AIA® Document A101® – 2017

Standard Form of Agreement Between Owner and Contractor where the basis of payment is a Stipulated Sum

Renovations to Jonesboro Recreation Center – Phase II
1421 West Nettleton Ave.
Jonesboro, Arkansas

6. Drawings: Sheet A100.1 – Partial demolition, floor plan, and reflected ceiling plan

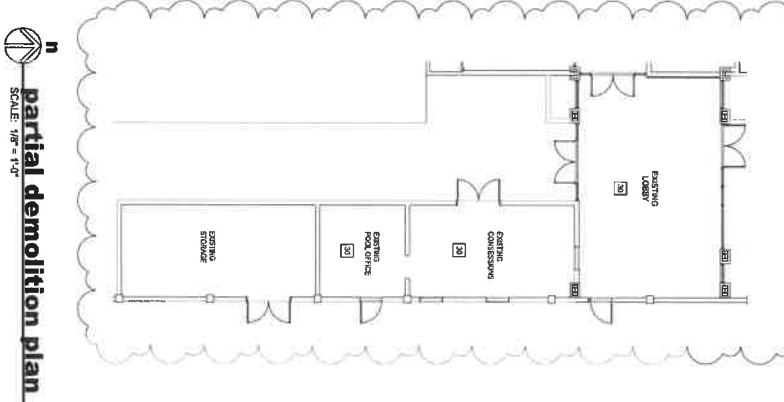
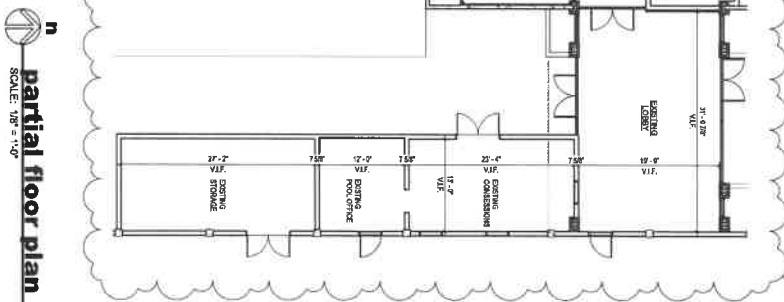
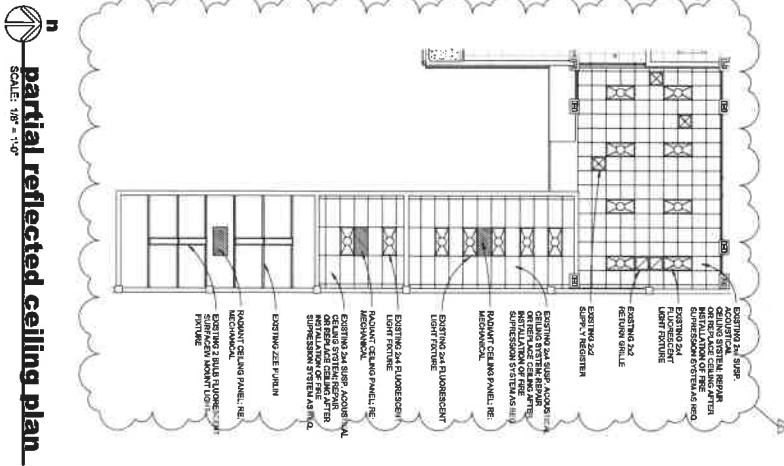
- A. Add the following sheet: A100.1– Partial demolition, floor plan, and reflected ceiling plan.

- B. This area of the building is indicated on Sheet C001 (siteplan) as existing lobby and existing storage (at the southeast corner of the main building).

Commission Number
M202
 2127
 Date February 23, 2022

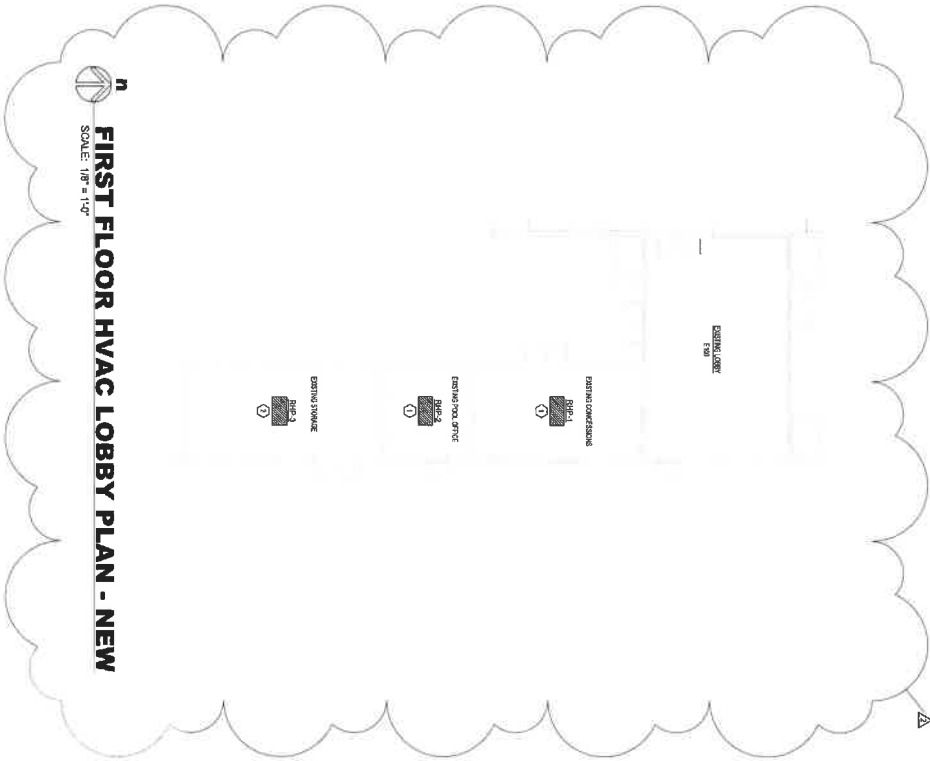
8. Drawings: Sheet M202 – FIRST FLOOR HVAC LOBBY PLAN - NEW

- A. Add radiant ceiling panel heaters to floor plan.
- B. Add Keyed Notes #1 and #2.
- C. Add “Radiant Ceiling Panel Heaters Schedule”.
- D. Revise Sequence of Operations.

SITE PLAN - FIRE PROTECTION
 SCALE: 1/8" = 1'-0"

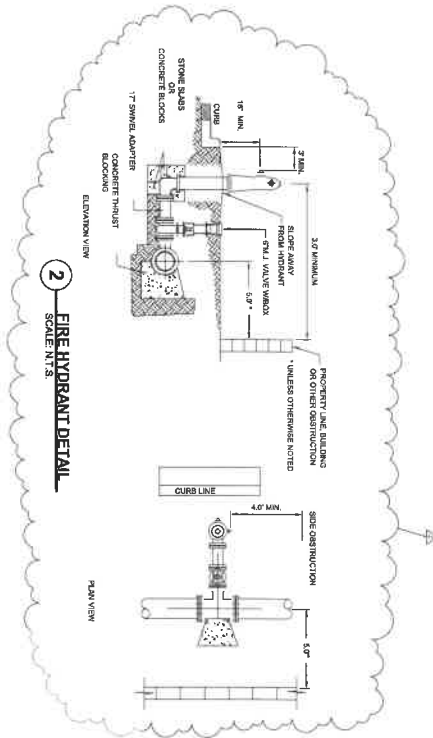
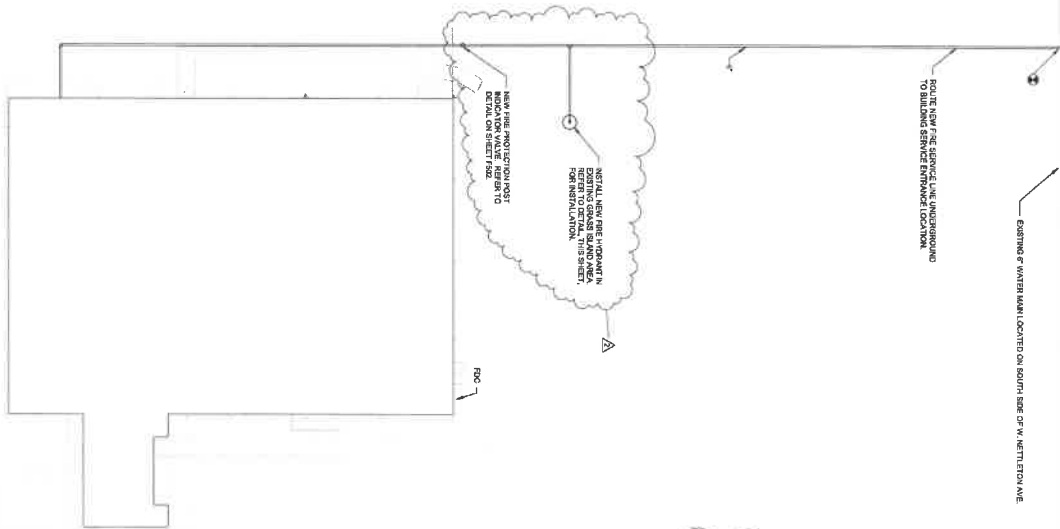
9. Drawings: Sheet F100 – SITE PLAN – FIRE PROTECTION

- A. Add fire hydrant to site plan.
- B. Relocate post indicator valve.
- C. Add Detail #2, “Fire Hydrant Detail”.

Commission Number
F102
2127
Dated: February 25, 2022

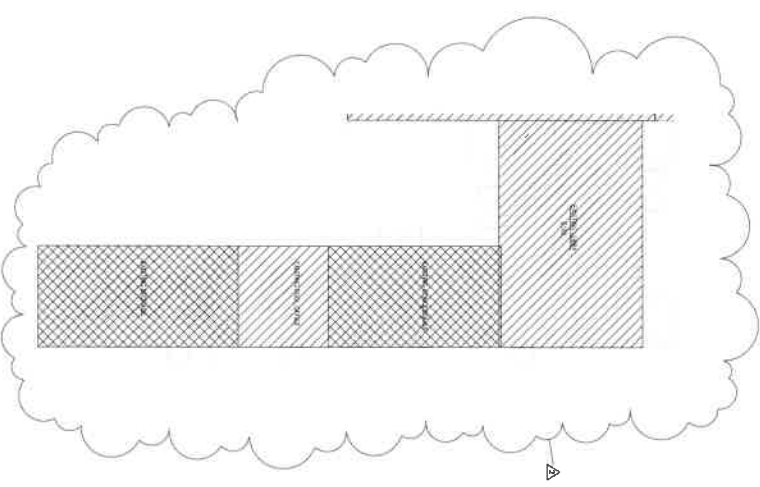
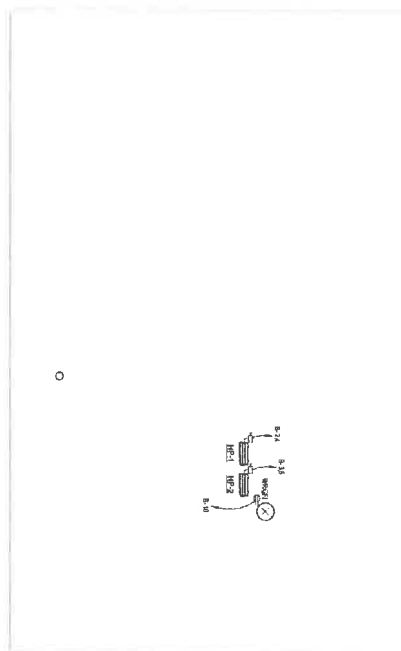
10. Drawings: Sheet F102 – FIRST FLOOR FIRE PROTECTION LOBBY PLAN - NEW

- D. Extend fire protection scope to include existing lobby, concession, office, and storage area.
- E. Add fire suppression hazard classification to existing lobby, concession, office, and storage.

Commission Number
2127
E104
Date: February 28, 2022

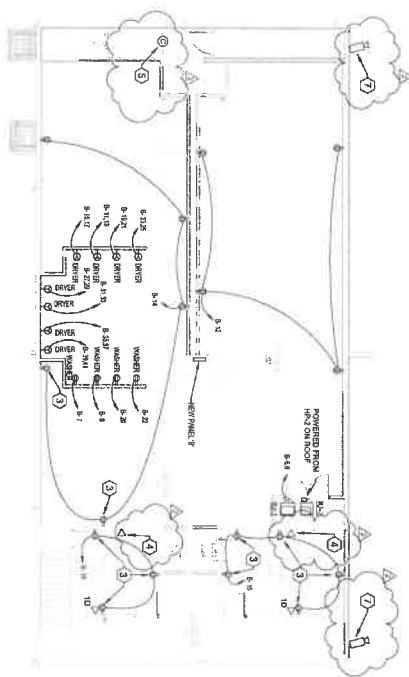
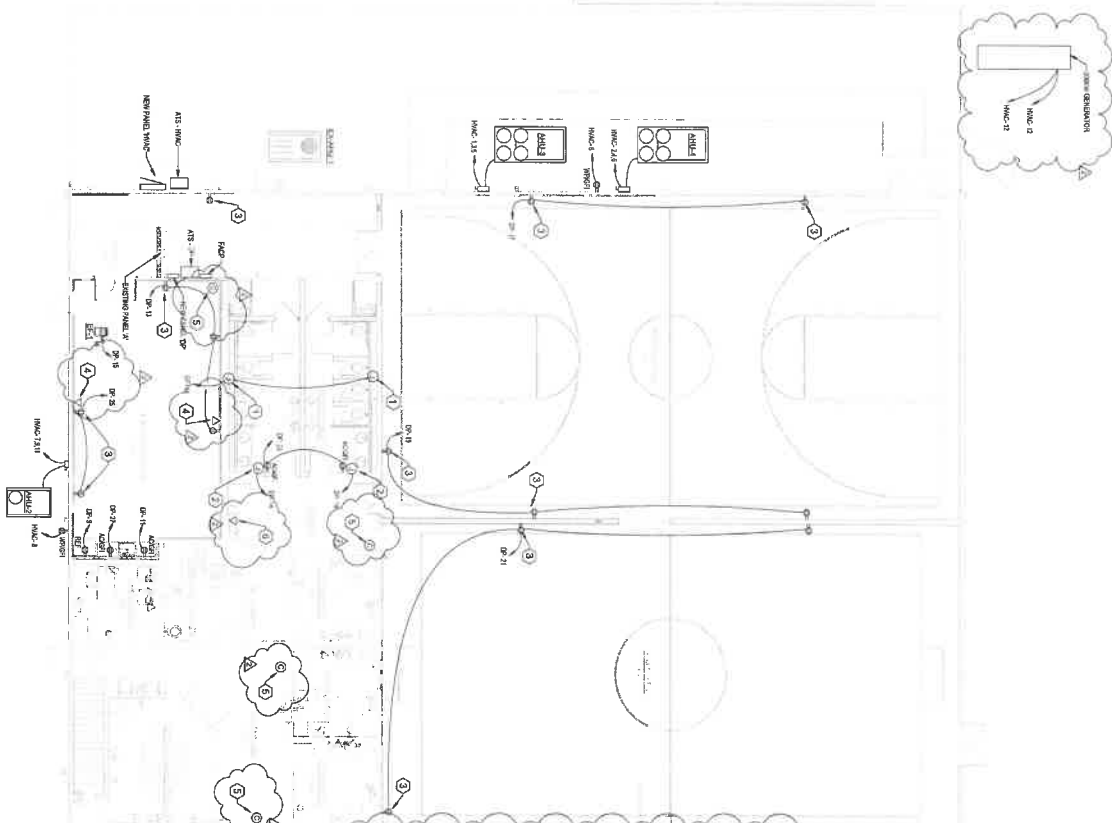
13. Drawings: Sheet E104 – ELECTRICAL PLANS - NEW

- J. ELECTRICAL PLAN – FIRST FLOOR – NEW and ELECTRICAL PLAN – SECOND FLOOR - NEW, updated to reflect additional data and camera locations.
- K. ELECTRICAL PLAN – FIRST FLOOR – NEW, updated generator location to the north west corner of the building.

ELECTRICAL PLAN - LOBBY
 SCALE: 1/8" = 1'-0"

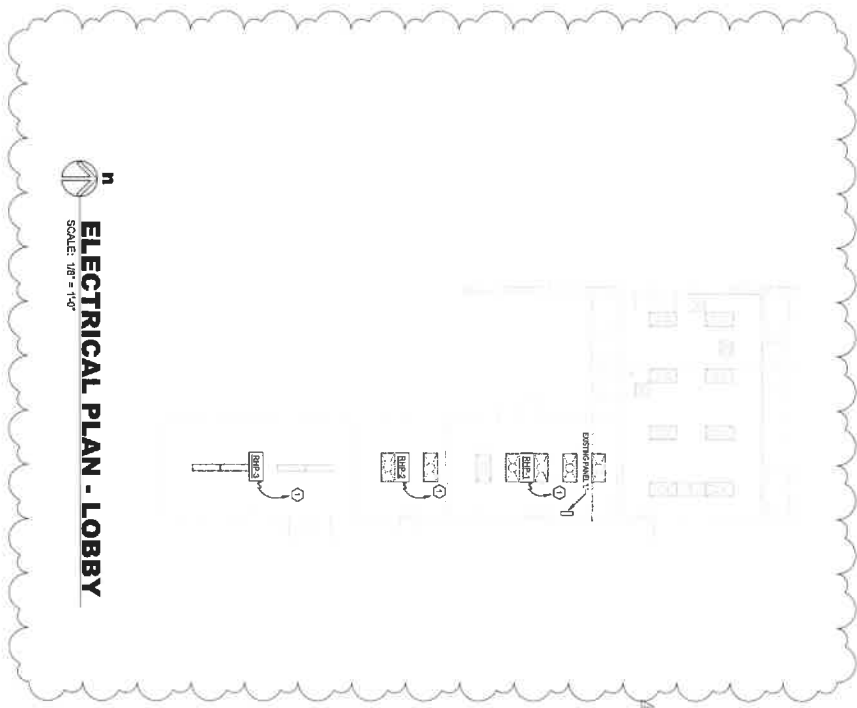
14. Drawings: Sheet E106 – ELECTRICAL PLAN – LOBBY – NEW

- L. ELECTRICAL PLAN – LOBBY – NEW, added power to new radiant heaters.
